LF PCN# A0090 Notification of label change on HEV OHEV050.ZXPCB2 fuse

Label 1

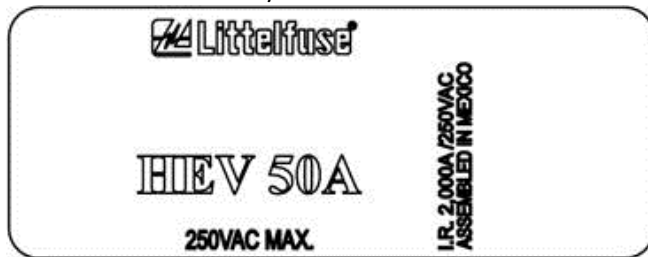
No changes have been made to the base fuse design or assembly processes, but the product label has been adjusted to show the new and improved voltage rating. Test results are available upon request.

Old Labels with 2000A/250VAC

New Labels with 2000A/275VAC

In response to market demands, Littelfuse validated our standard 50A HEV **OHEV050.ZXPCB2** fuse to a higher voltage rating than originally indicated on the label and datasheet. Our testing has successfully validated the 50A HEV fuse for use in customer applications up to 275VAC.
